Addendum 15 – UN Regulation No. 16

Revision 9 - Amendment 5

08 series of amendments – Date of entry into force: 28 May 2019

Uniform provisions concerning the approval of:

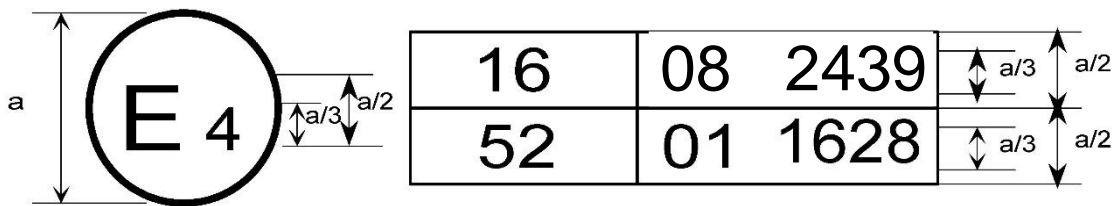
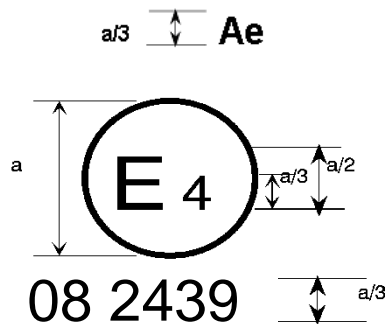
Annex 2, amend to read:

The above ... amended by the 08 series of amendments.

The above ... included the 08 series of amendments and Regulation No. 52 the 01 series of amendments.
